ASSESSMENT OF DAM SAFETY OF COAL COMBUSTION SURFACE IMPOUNDMENTS – FINAL REPORT

**City Utilities of
Springfield**

**John Twitty Energy
Center
Springfield, Missouri**

May 2014

Photograph 5.9. Pump Station Regulating Outlets for both Impoundments

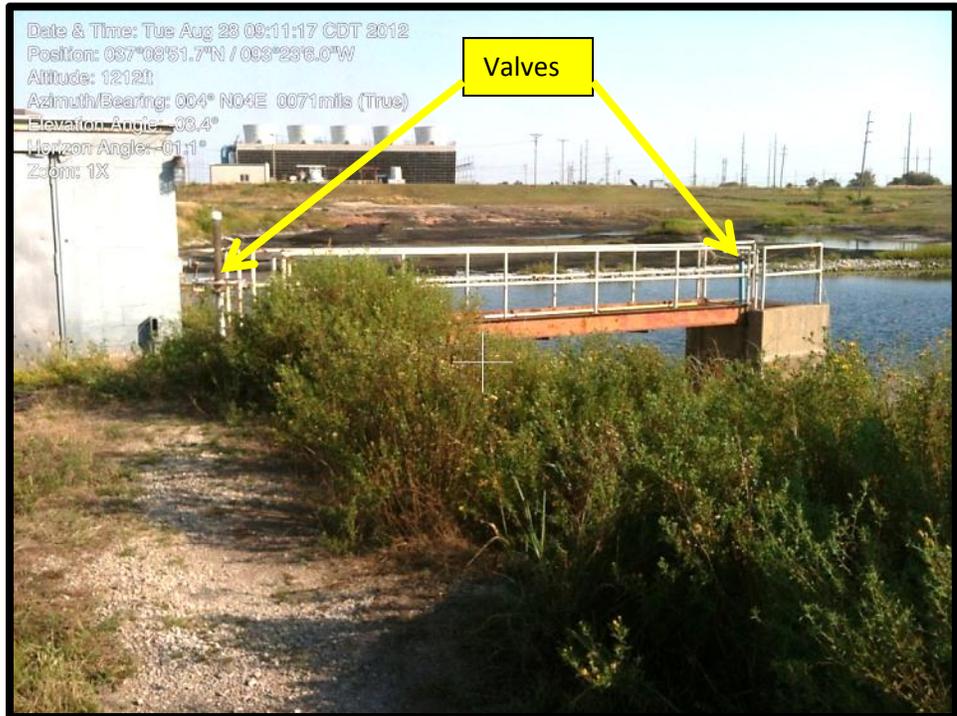
The outlet system consists of a pump station, a weir structure and associated valves and piping. The system appeared to be in good condition, and water was flowing through the weir indicating it is operational (**Photographs 5.9, 5.10, 5.11**). Water is discharged by gravity discharge from the CCW impoundments through the weir structure. The pump station is used to recycle clear water from the CCW impoundments back to the power plant for boiler seals and bottom ash conveyance. The weir is a concrete structure covered with a steel grate located on the outside slope of the south embankment. According to the plant representatives, the weir structure is used to measure discharge through the outlet.
